ENVIRONMENTAL LAW & POLICY CENTER

January 11, 2012

Re: Draft Environmental Impact Statement for Combined License (COL) for Enrico Fermi Unit 3, NUREG-2105, Docket No. NRC-2008-0566

Figure 1. Karst areas identified in Monroe County, MI (Source: SEMCOG, 2010)

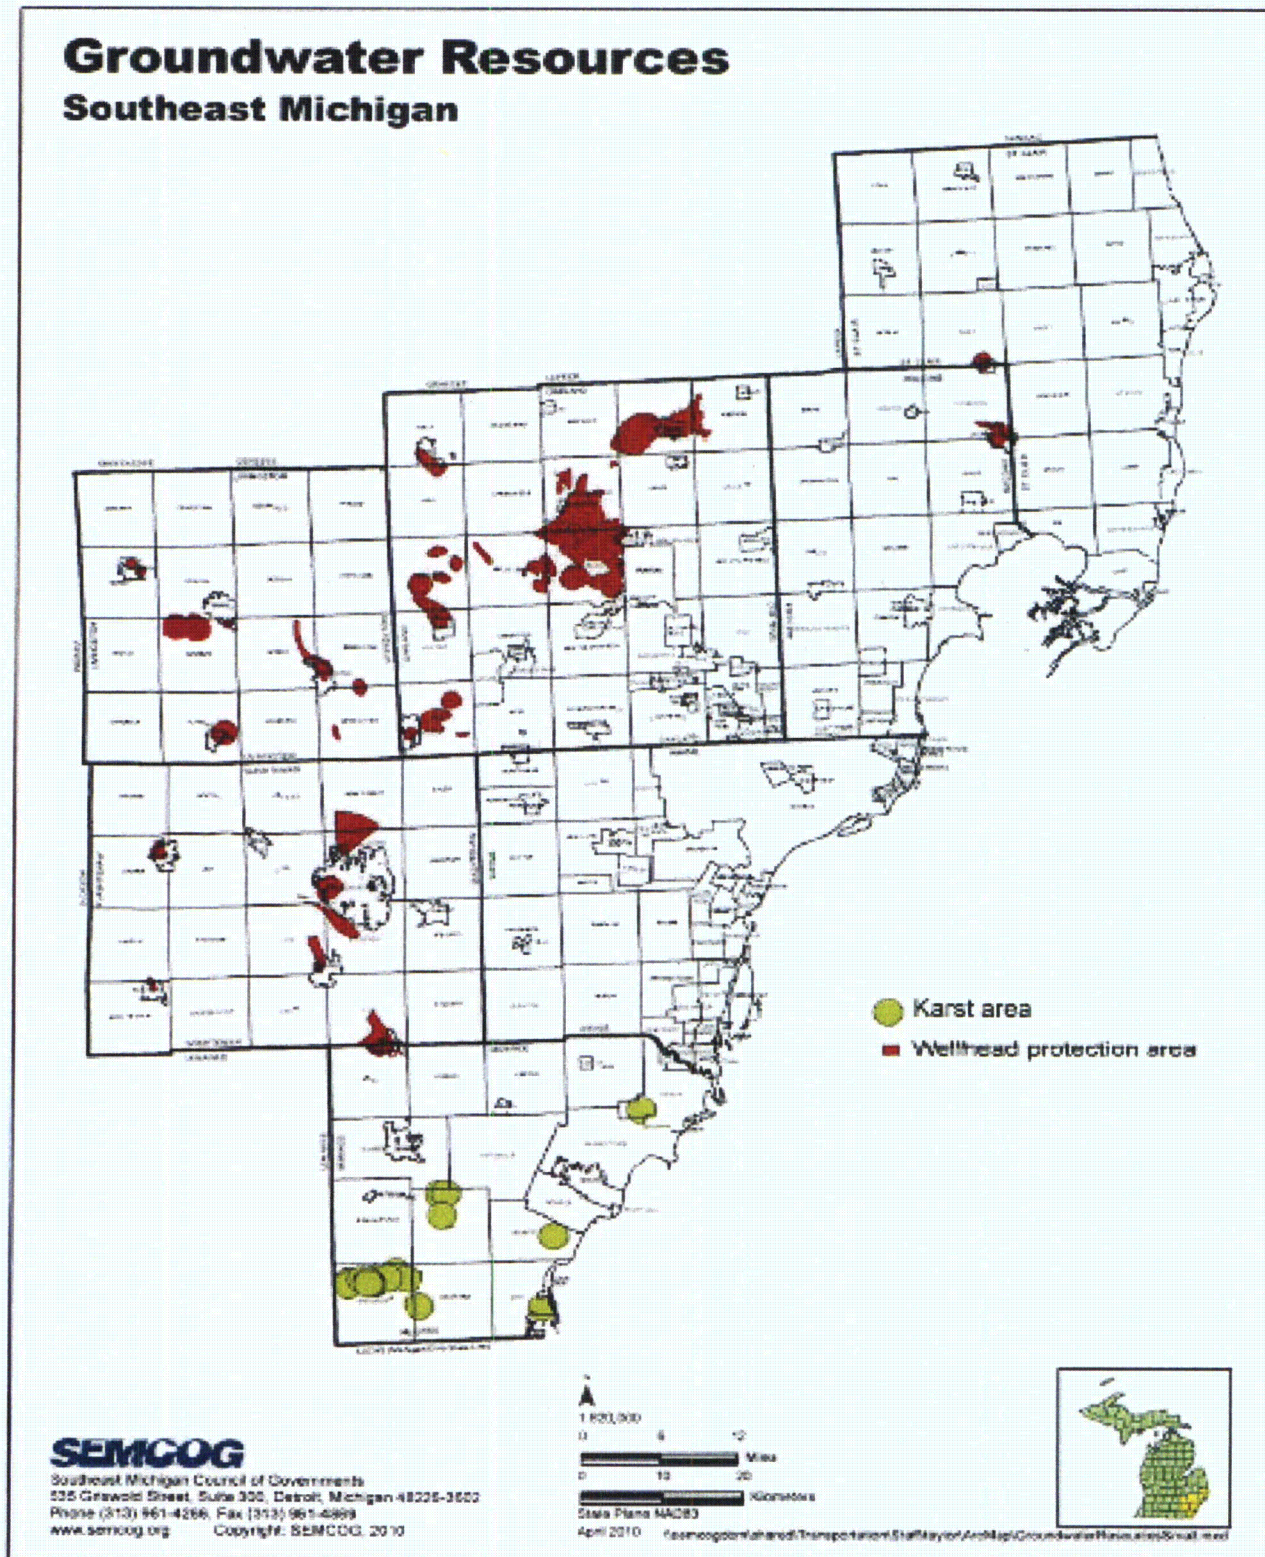
Section 2.5.3.8.2 of the FSAR claims that “the potential for nontectonic deformation at the Fermi 3 site is negligible,” and that “there is no evidence of nontectonic deformation at the Fermi 3 site in the form of unloading phenomenon (i.e., pop-up features), glacially-induced faulting, salt migration, dissolution or collapse related to karst, or volcanic intrusion.” But Figure 1 (below), which identifies several known Karst areas in Monroe County, Michigan where the Fermi site is located, demonstrates that a more thorough search for this type of subsurface formation in the area is warranted. Two concerns related to this issue include:

- Risk of future subsidence at the site that could damage the structural integrity of the reactor containment building, existing or potential radioactive waste storage facilities, and other important structures.
- Risk of contamination of groundwater beyond the Fermi site via unknown flow pathways that are typically inherent in Karst formations even where obvious underground voids are not identified through bore sampling and other techniques.

More evaluation of these risks is necessary to reduce the uncertainty raised by the existence of multiple Karst formations so near to the proposed project site as shown in Figure 1.
